ADDENDUM NO. 1

SANITARY SEWER MANHOLE REHABILITATION; PROJECT NO. 2023-S-10

This Addendum covers the following additions, modifications, and clarifications to the Bid Manual and Drawings for the above-mentioned project scheduled to close 2:00 pm CST, Thursday, January 30, 2024.

SHEET 7 of 26

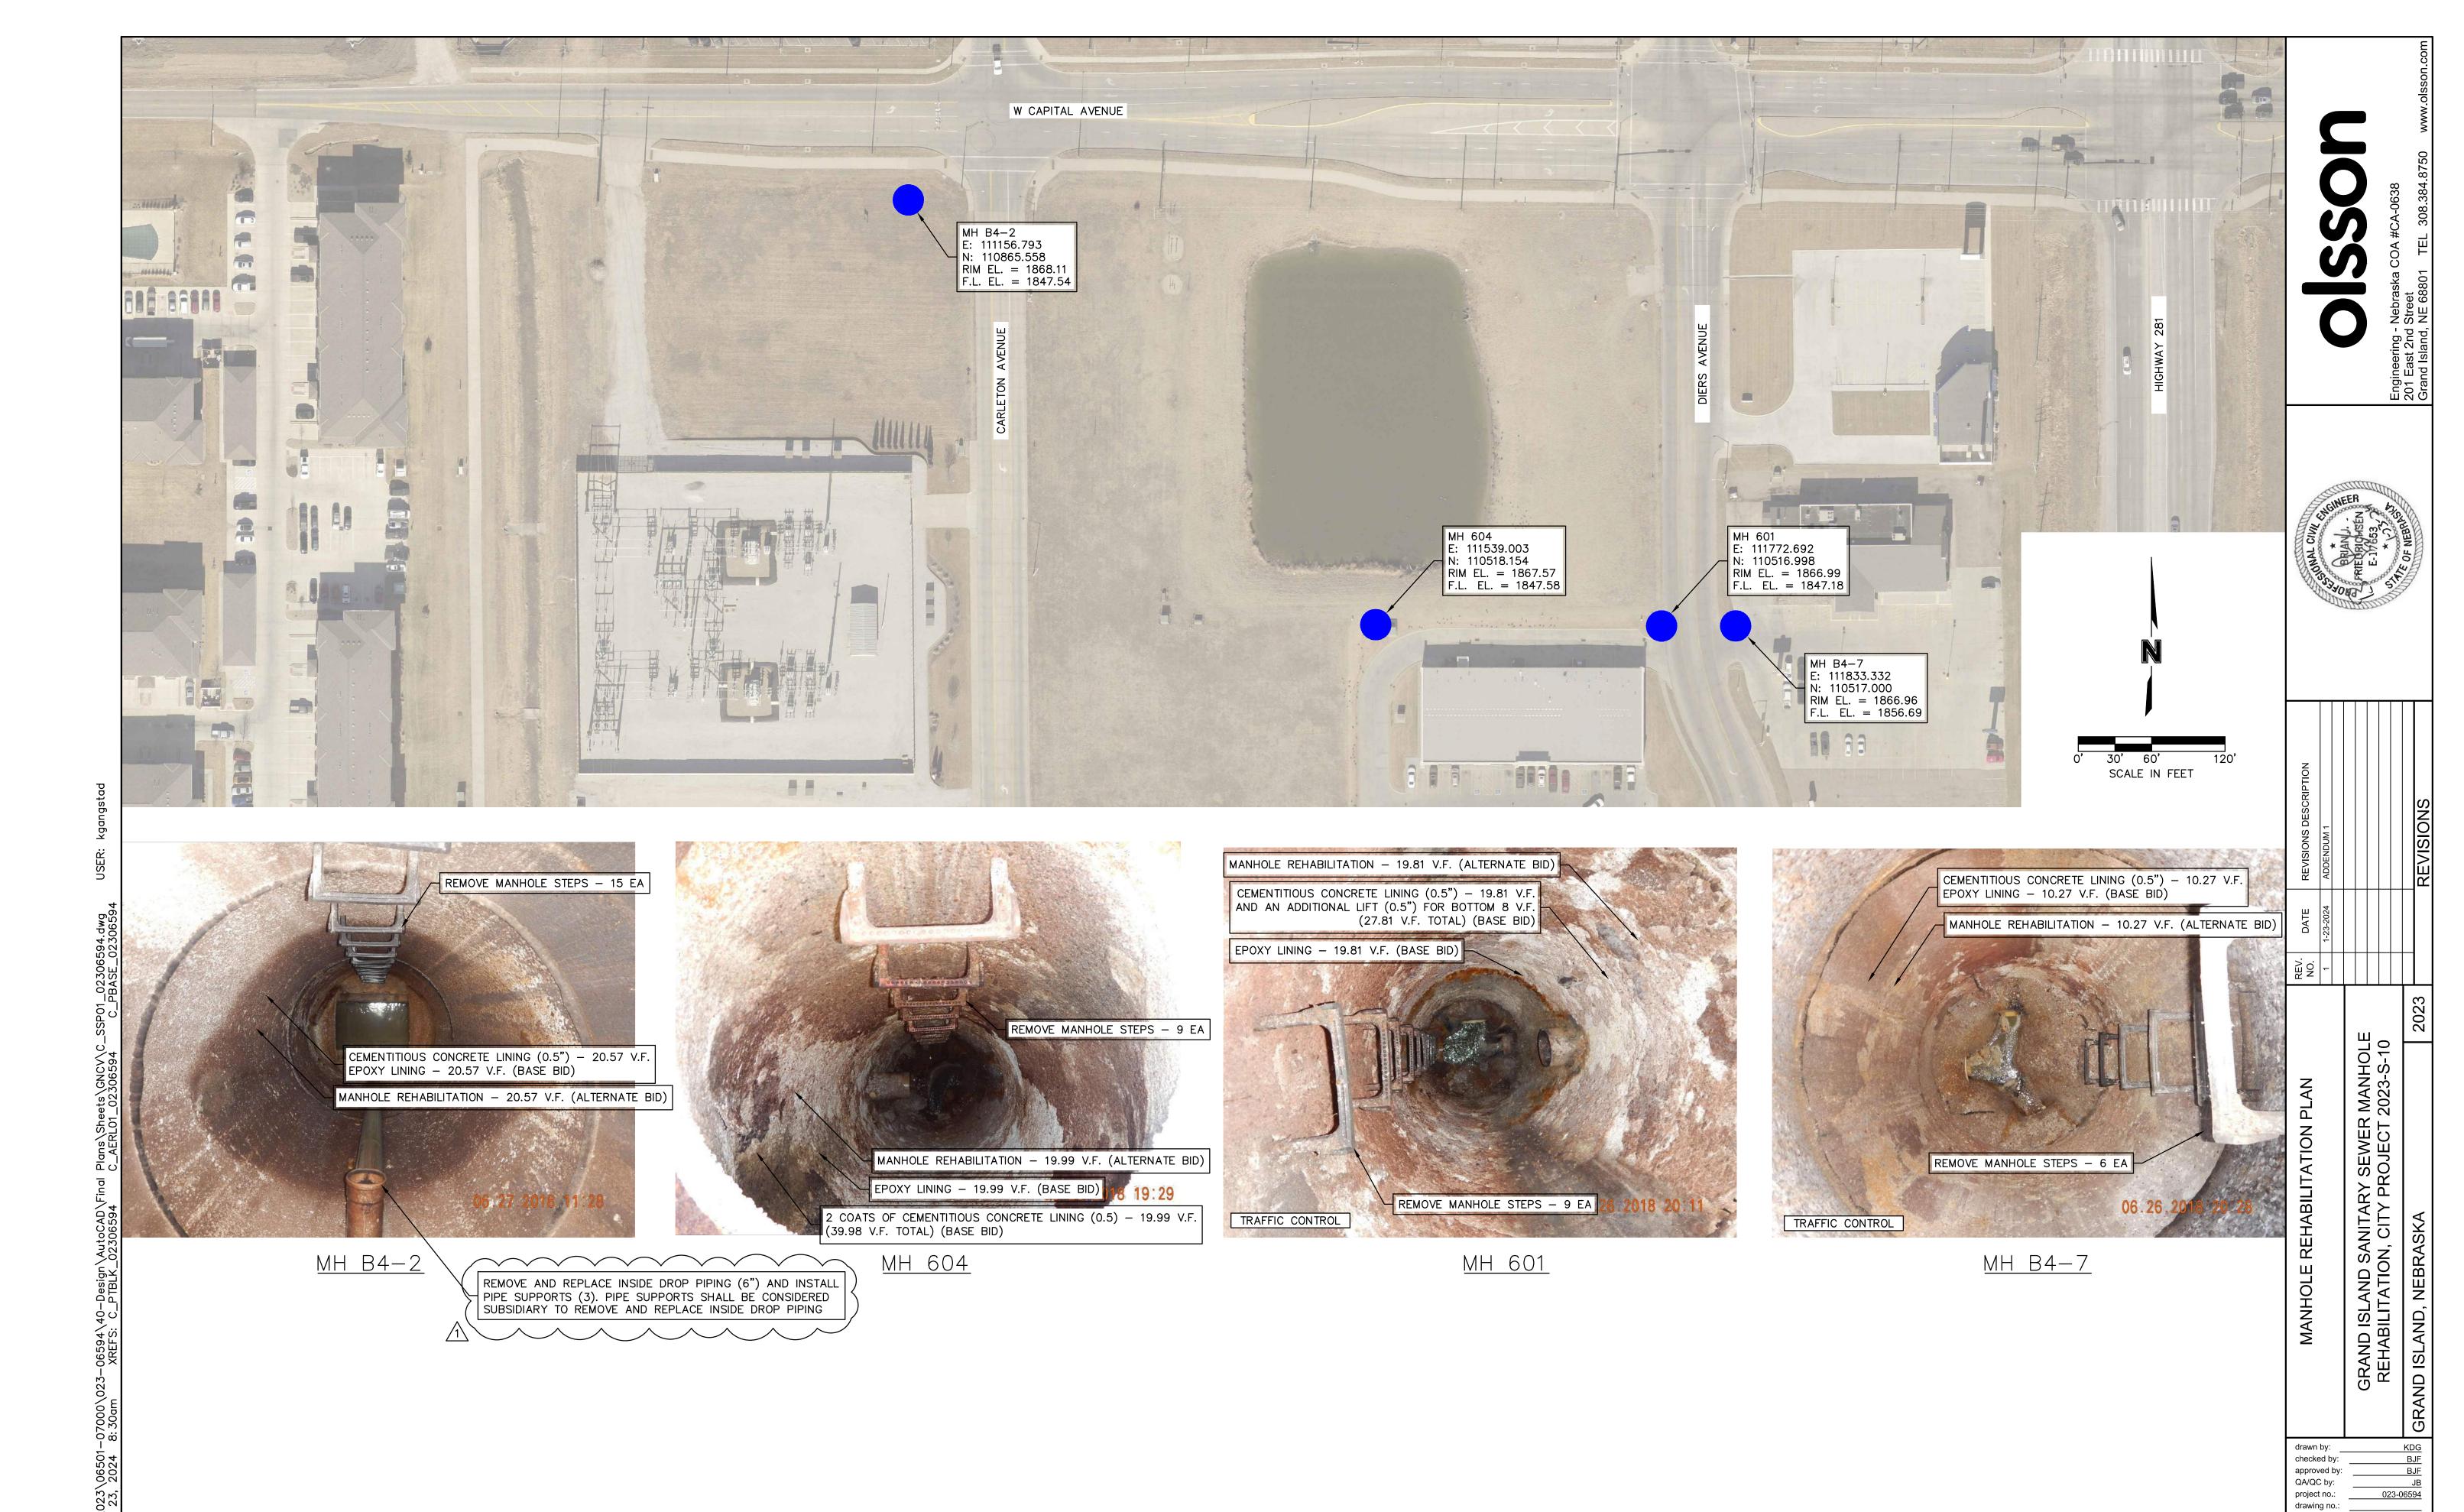
- 1. Remove and replace sheet 2 of 26 GENERAL NOTES with the attached.
- Remove and replace sheet 7 of 26 MANHOLE REHABILITATION PLAN with the attached.
- 3. Remove and replace sheet 9 of 26 MANHOLE REHABILITATION PLAN with the attached.
- 4. Remove and replace sheet 13 of 26 MANHOLE REHABILITATION PLAN with the attached.
- 5. Remove and replace sheet 17 of 26 MANHOLE REHABILITATION PLAN with the attached.
- 6. Remove and replace sheet 23 of 26 MANHOLE REHABILITATION PLAN with the attached.

MANHOLE REHABILITATION — 20.07 V.F. (ALTERNATE BID) CEMENTITIOUS CONCRETE LINING (0.5") — 20.07 V.F. EPOXY LINING — 20.07 V.F. (BASE BID) REMOVE MANHOLE STEPS - 10 EA

MH B4-3

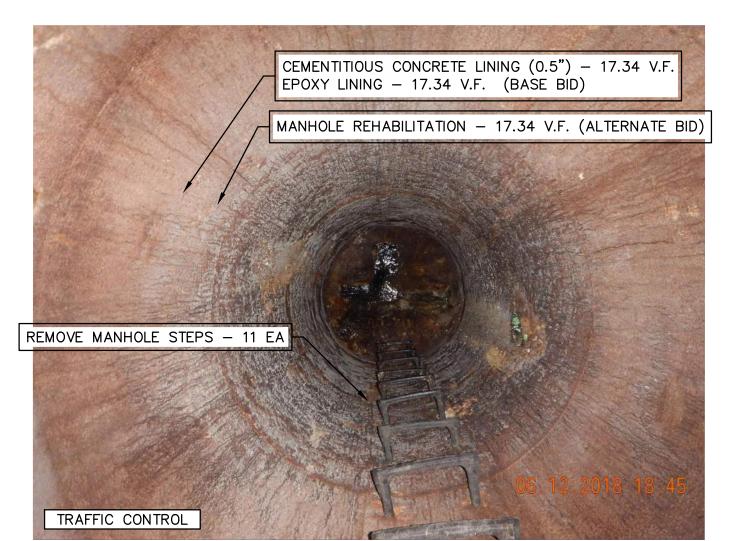
PREVIOUS EPOXY LINER
PRODUCT TO BE REMOVED
WAS RAVEN LINING SYSYTEM

<u>MH 622</u>

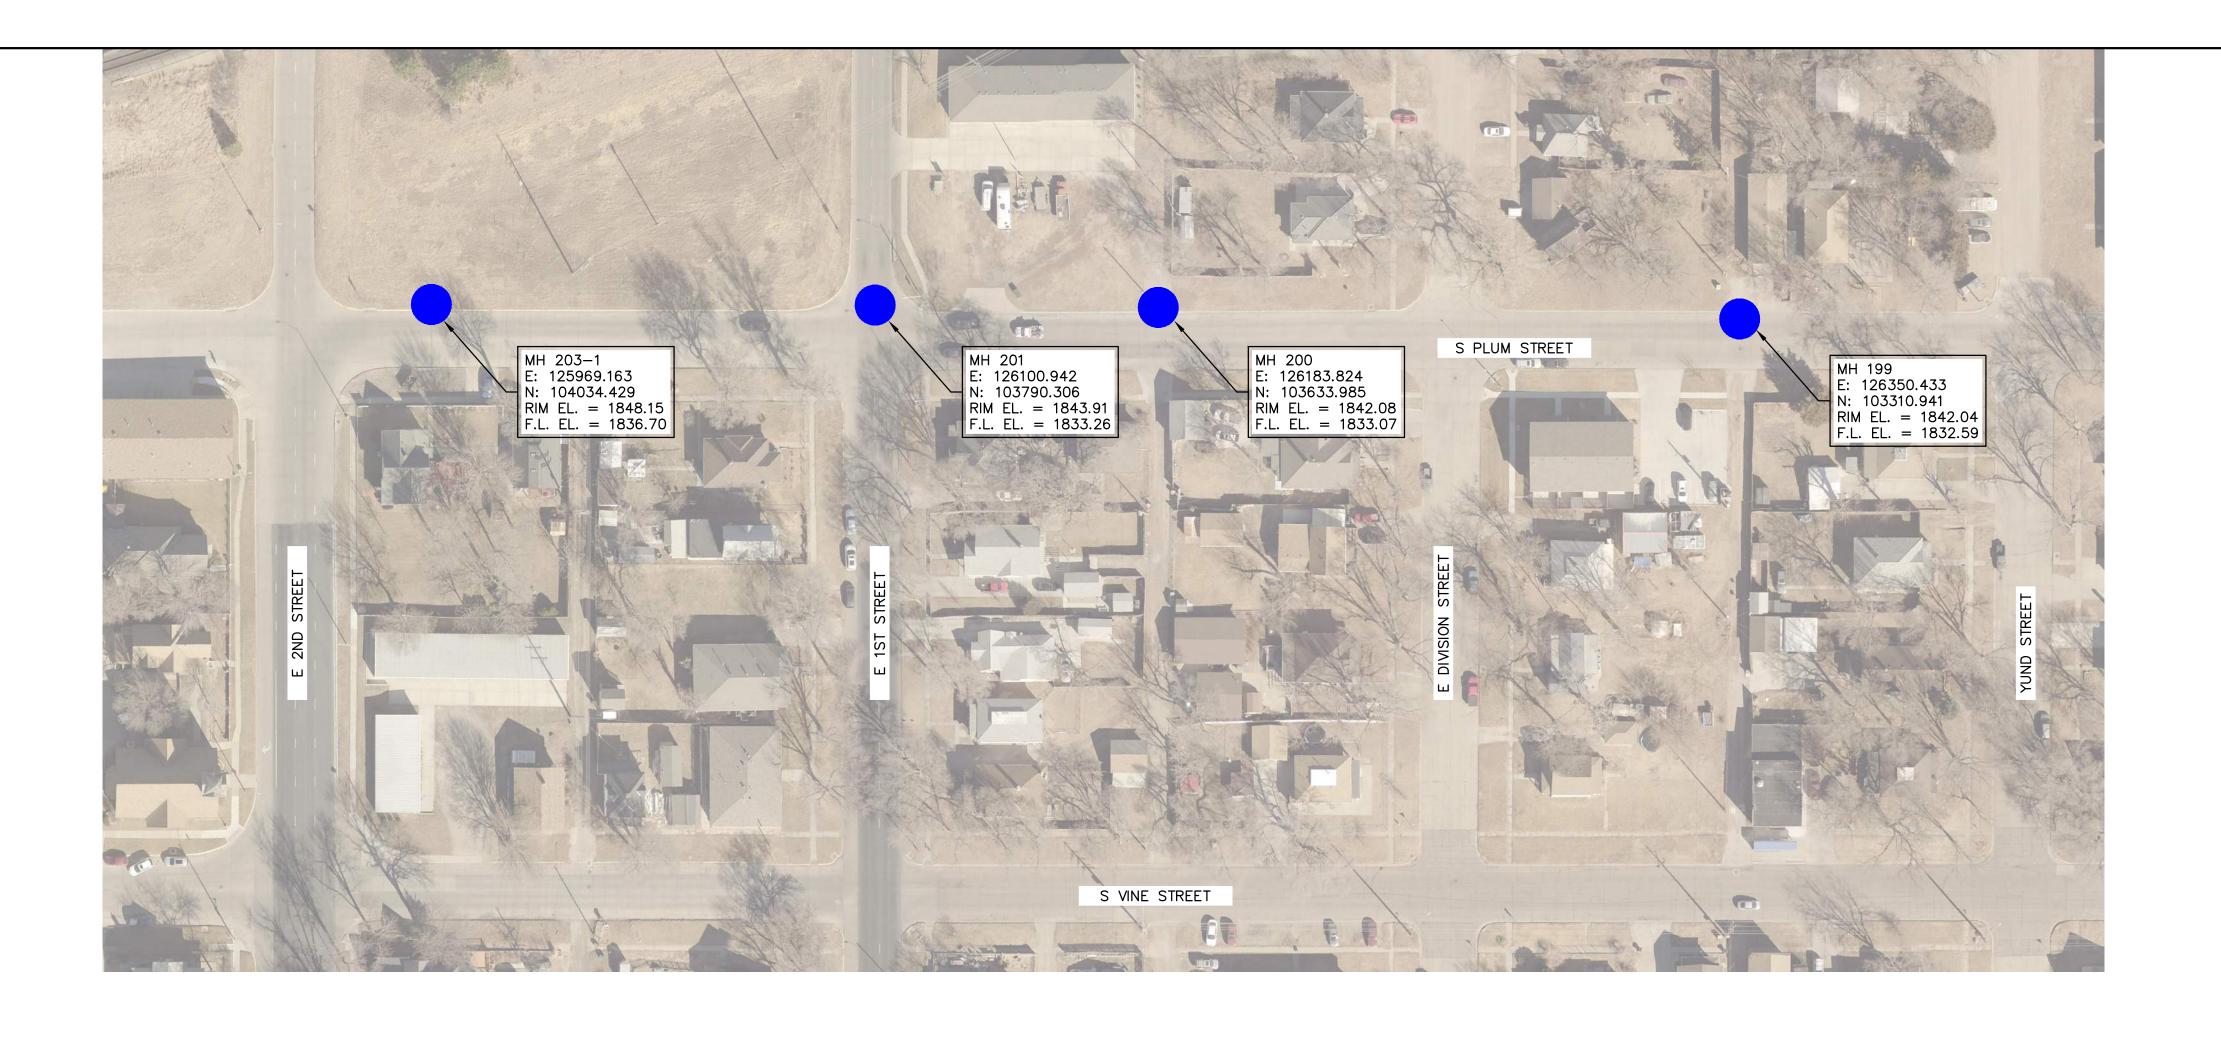
REMOVE AND REPLACE INSIDE DROP PIPING (8") AND INSTALL PIPE SUPPORTS (3). PIPE SUPPORTS SHALL BE CONSIDERED SUBSIDIARY TO REMOVE AND REPLACE INSIDE DROP PIPING

MH 203-1

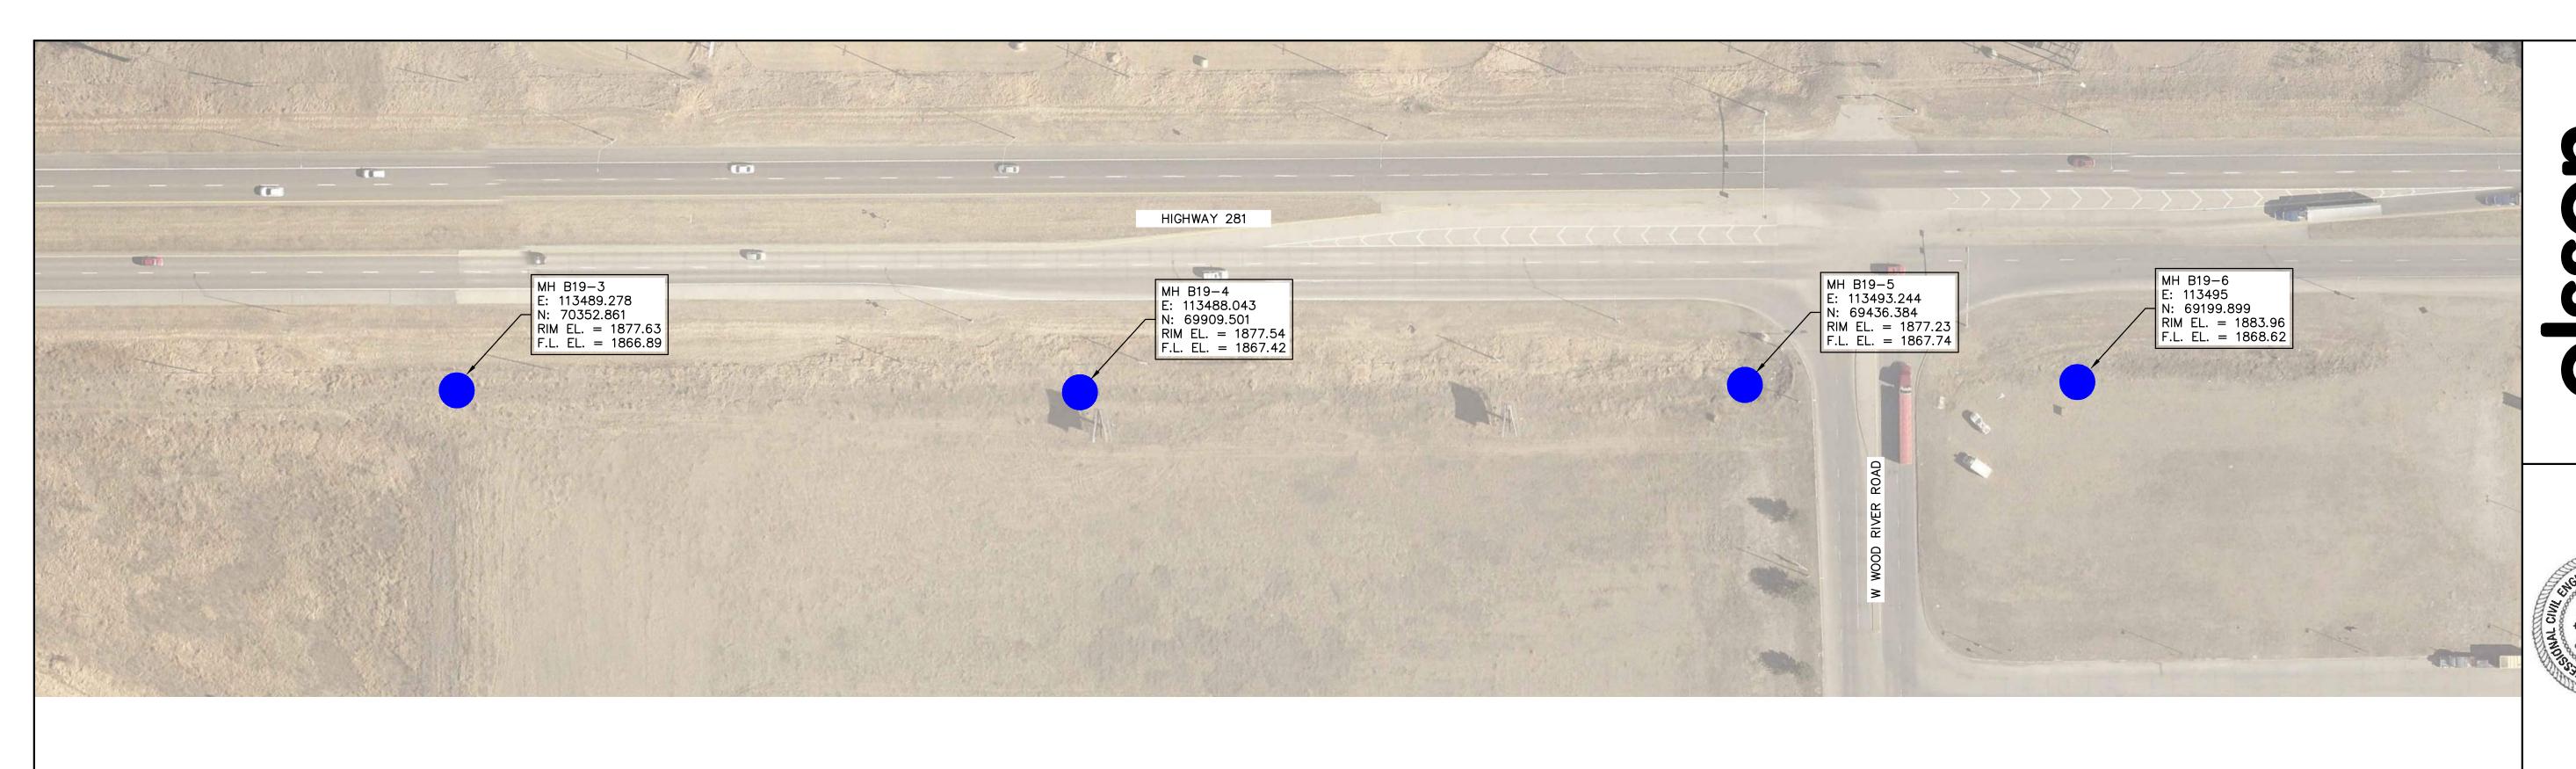
CONTRACTOR WILL BE REQUIRED TO USE A FLOW THROUGH PLUG AT THIS MANHOLE DUE TO THE VERTICAL OFFSET OF THE INLET AND OUTLET PIPE. PIPE SIZE IS 24".

CEMENTITIOUS CONCRETE LINING (0.5") — 11.45 V.F. EPOXY LINING — 11.45 V.F. (BASE BID)

MANHOLE REHABILITATION - 11.45 V.F. (ALTERNATE BID)

<u>MH B19-5</u>

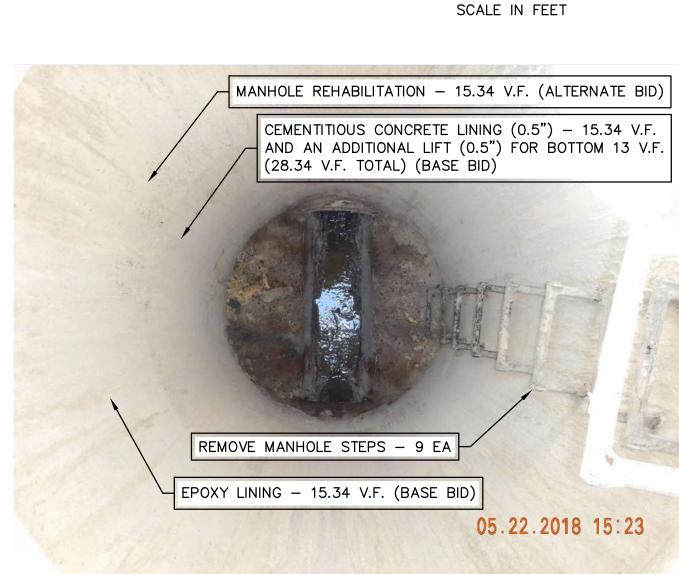
INSTALL ELASTOMERIC CHIMNEY INFILTRATION BARRIER — 1 EA.

MANHOLE REHABILITATION — 9.49 V.F. (ALTERNATE BID) CEMENTITIOUS CONCRETE LINING (0.5") — 9.49 V.F. AND AN ADDITIONAL LIFT (0.5") FOR BOTTOM 8 V.F. (17.49 V.F. TOTAL) (BASE BID) EPOXY LINING - 9.49 V.F. (BASE BID) REMOVE MANHOLE STEPS - 7 EA .13.2018 10:49
